**North Rockland High School Projects – Phase 2**

**MSA File No. 43045**

**NOTICE TO BIDDERS**

Re: **ADDENDUM NO. 1**

UTILITY DETAILS	C-720
Drawing Title	of X

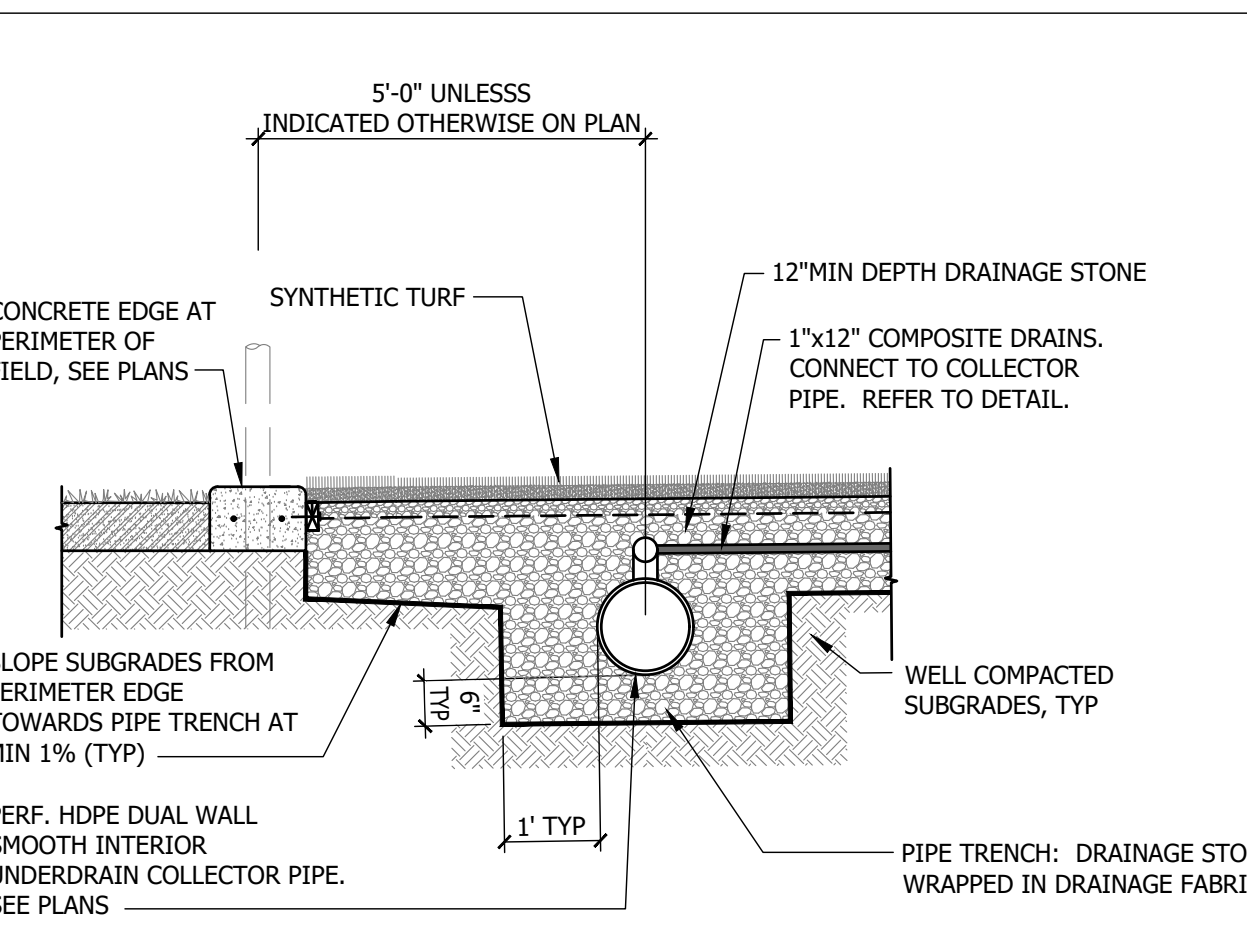
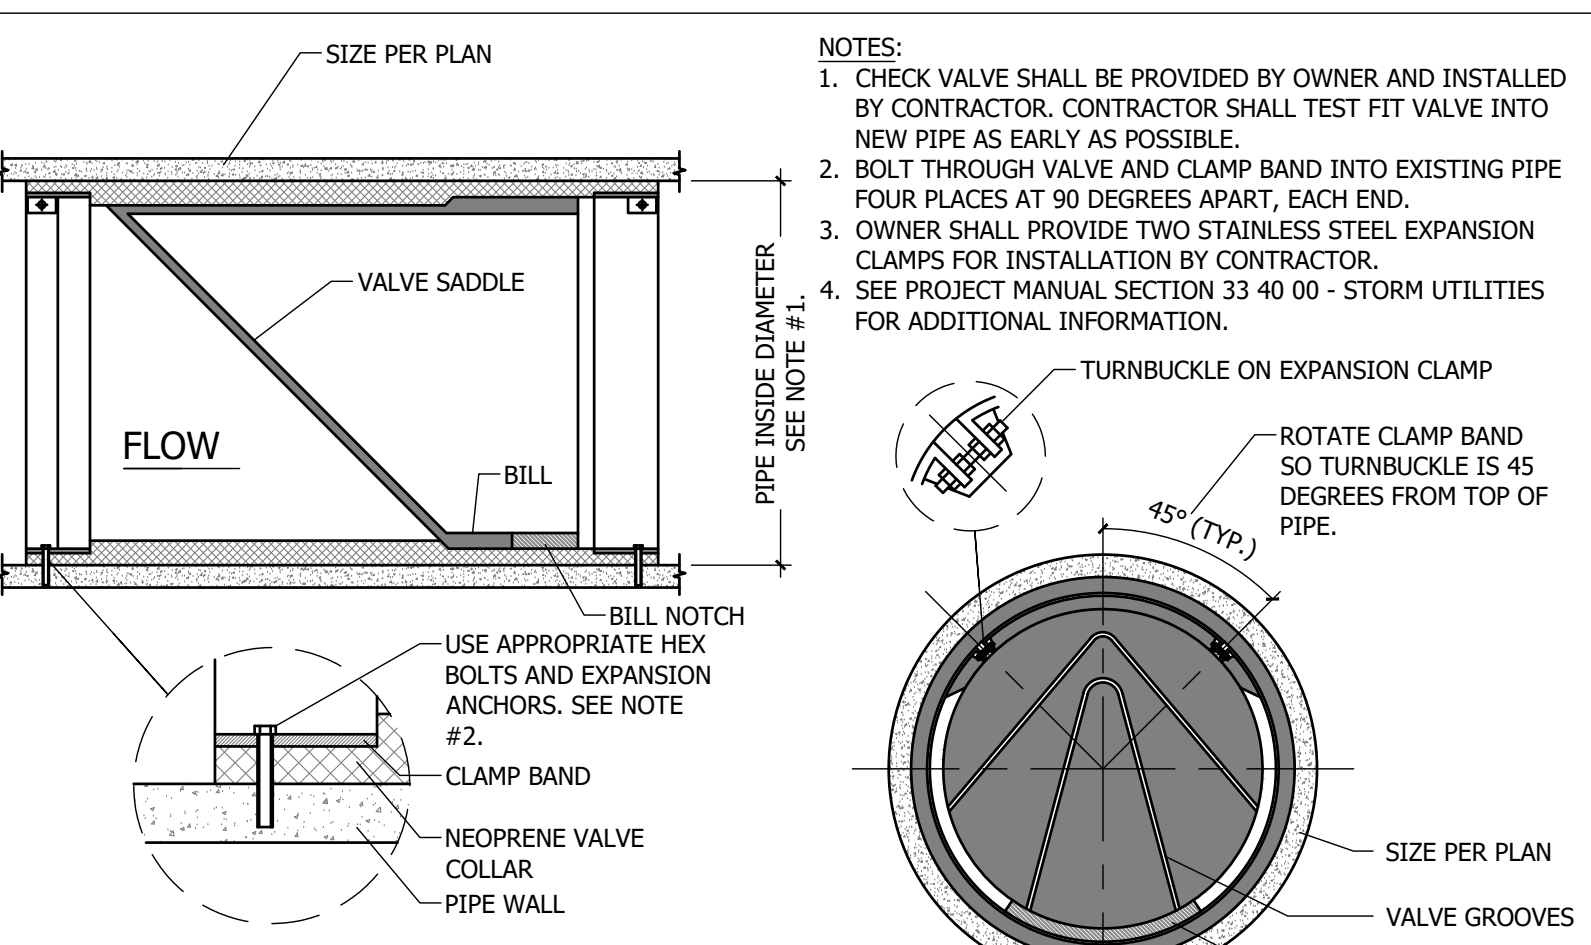
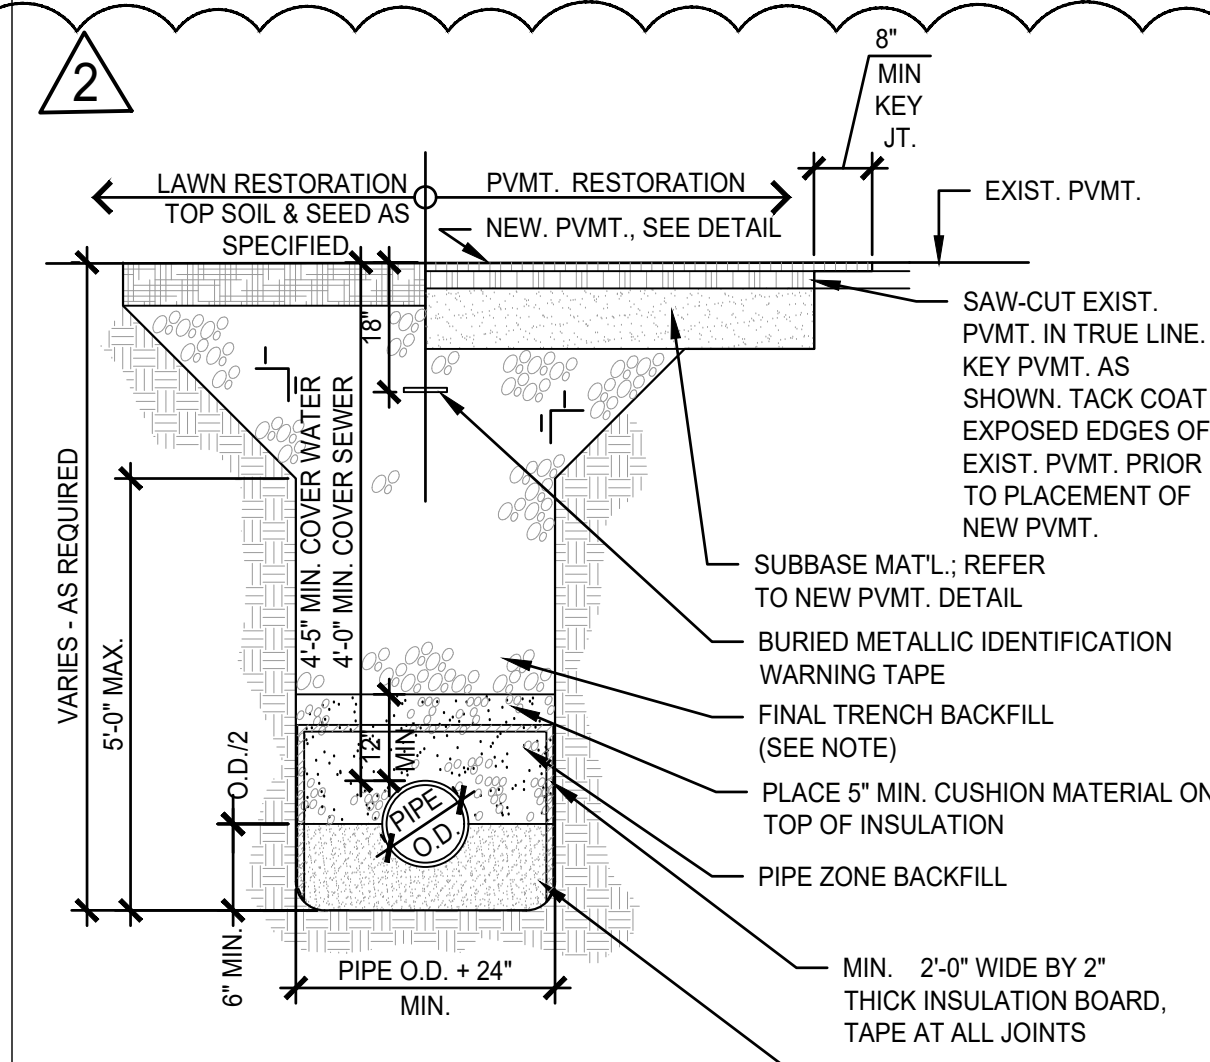
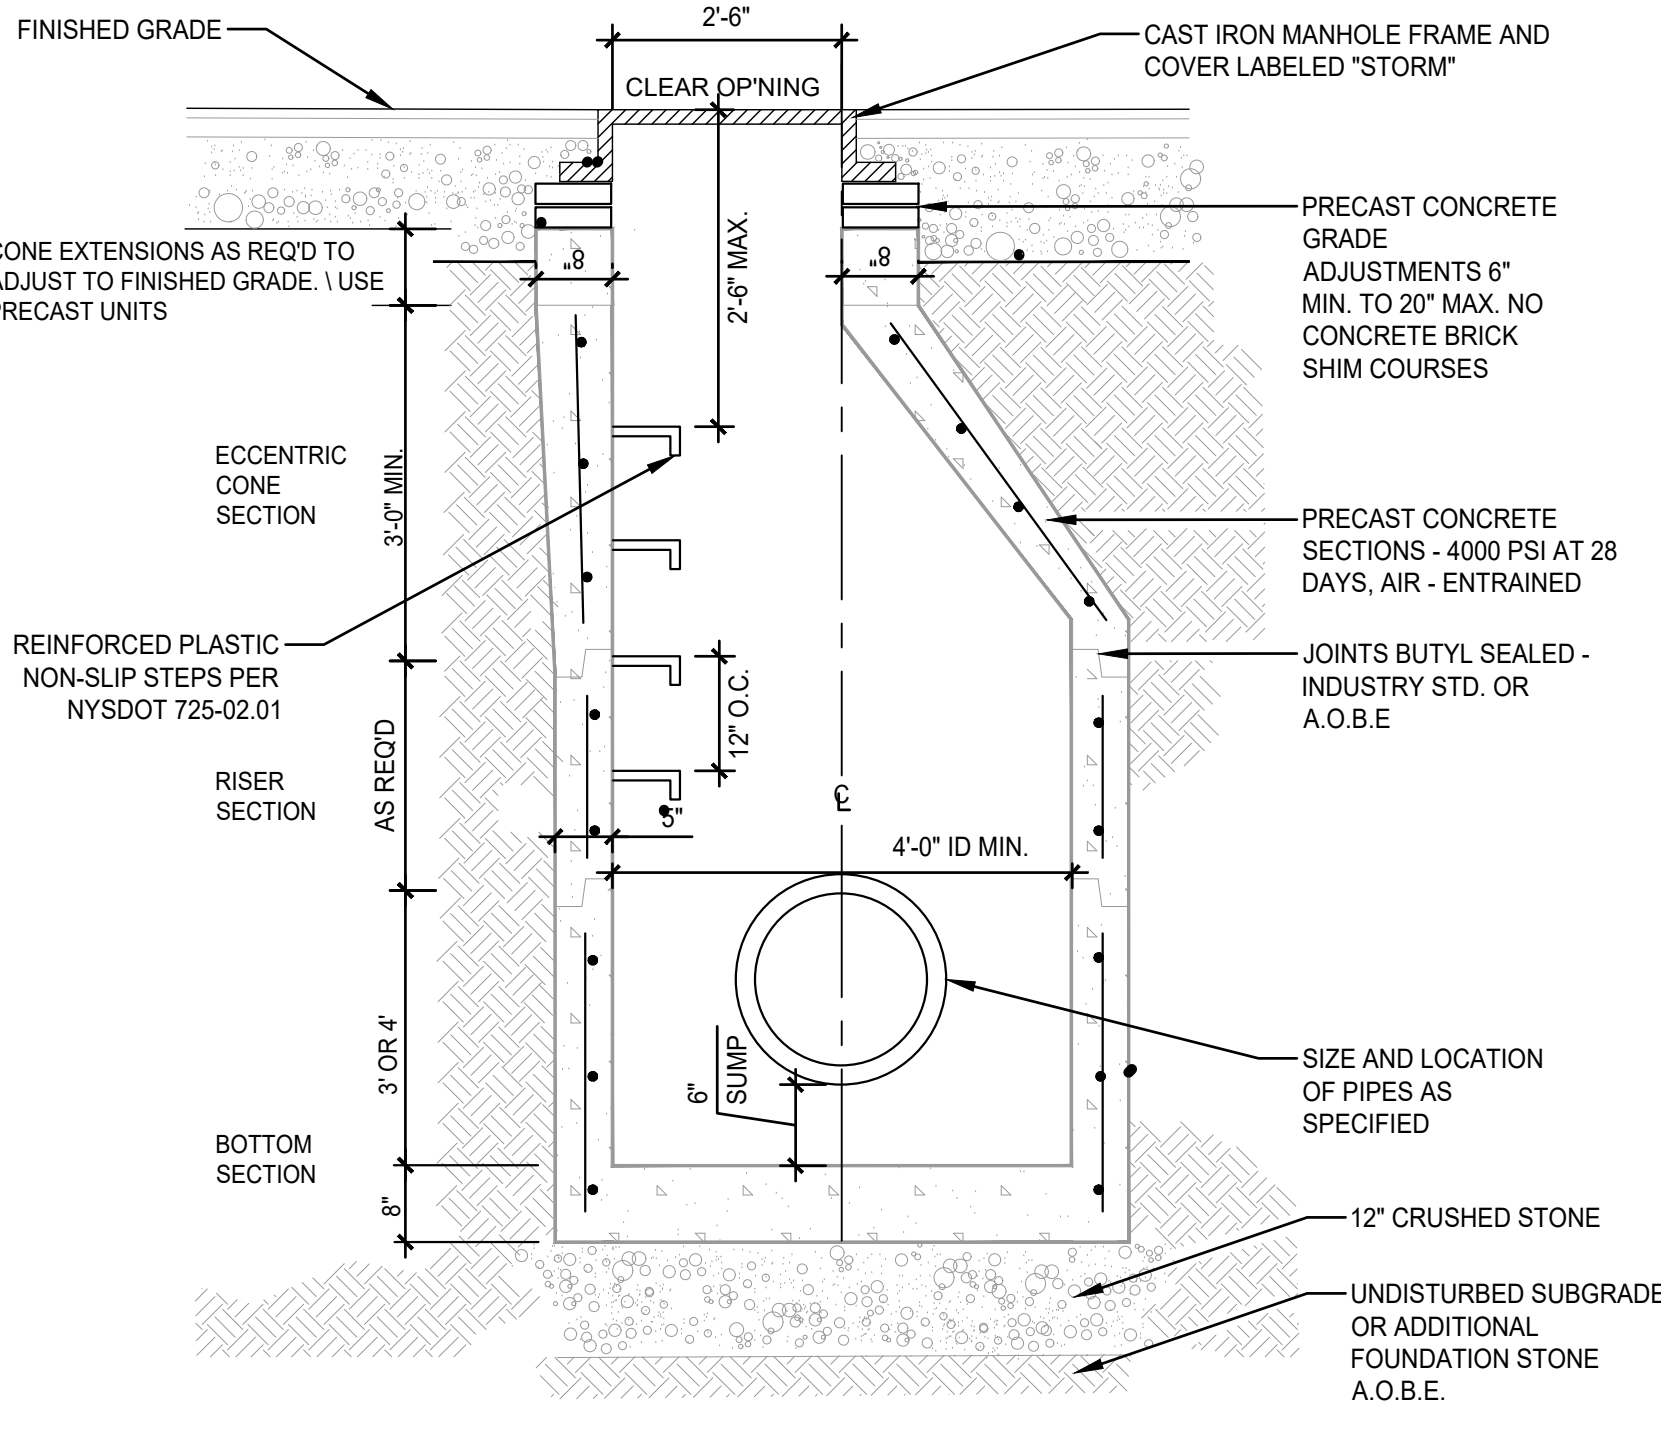
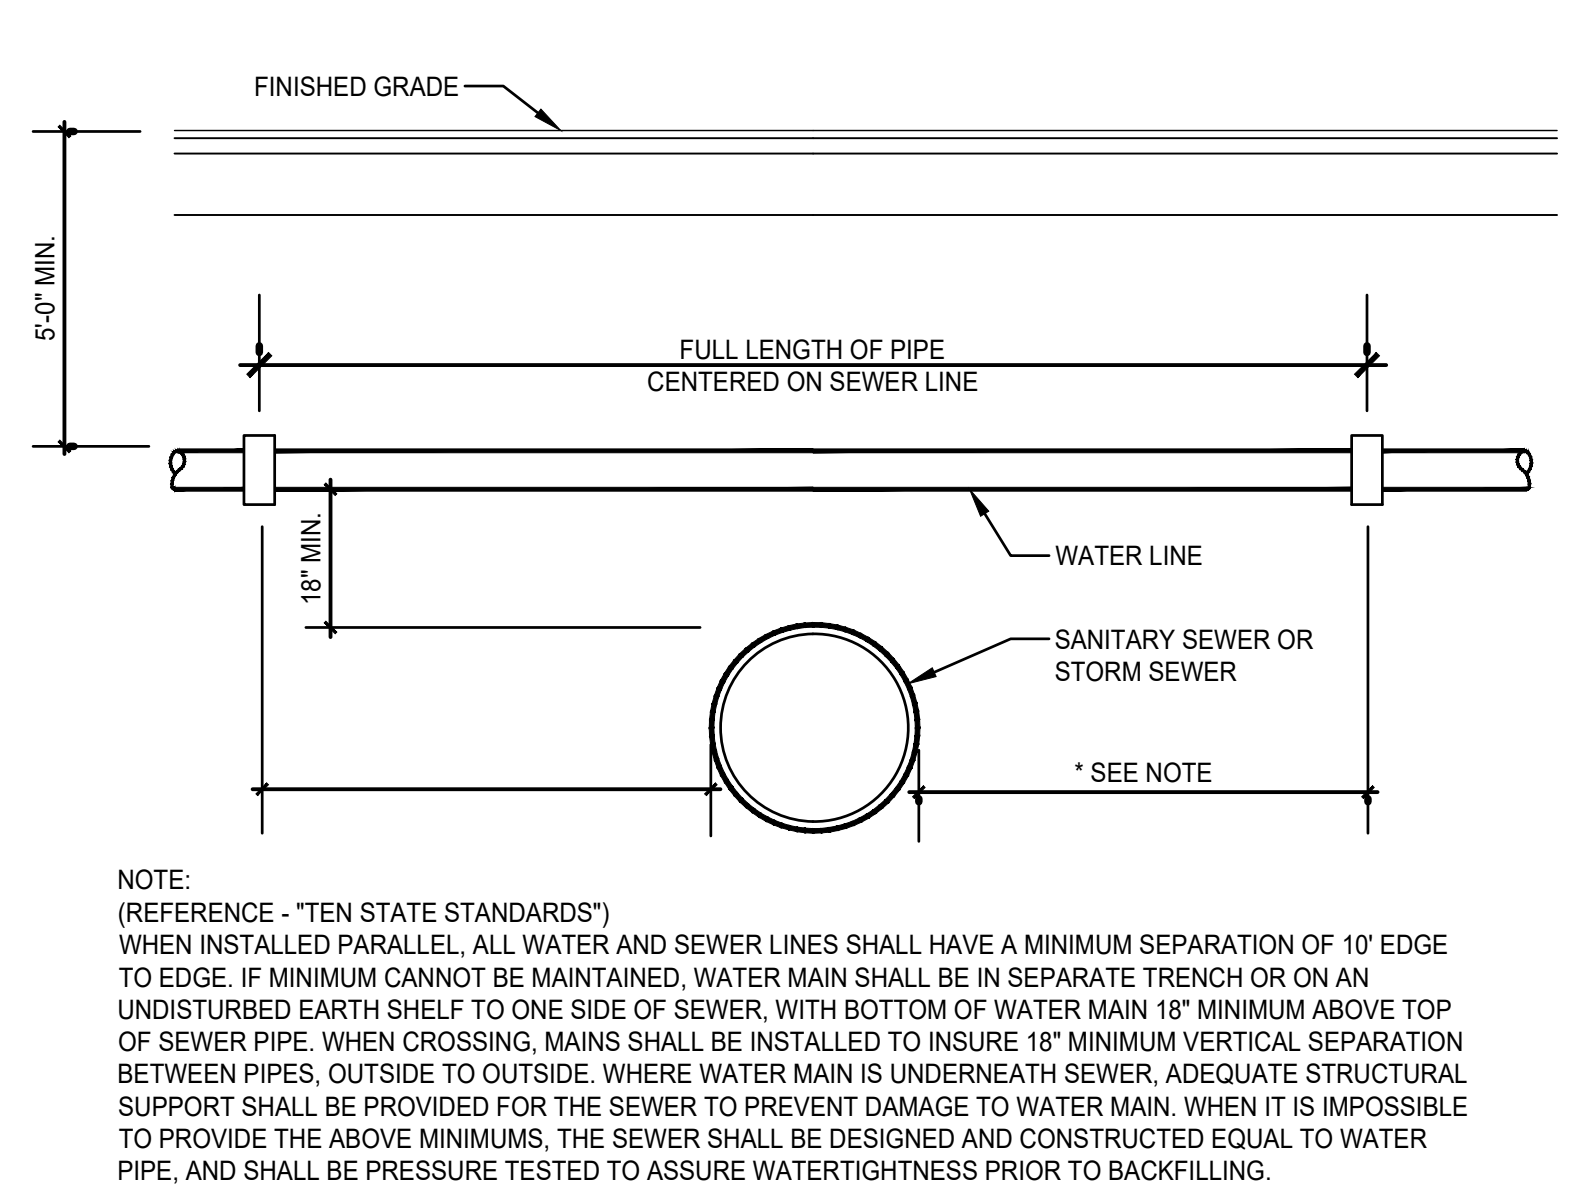
Please see revisions to drawings C-410, C-420, and C-720 for locations where changes in grade will require existing active 4" and 8" water lines to be lowered to maintain proper burial depth. Bidder shall carry cost in base bid to cut and replace sections of 4" and 8" water lines in areas shown. Bidder shall also carry cost in base bid for adding insulation over existing water lines where shown. Existing detectable warning tape shall be replaced in all disturbed locations.
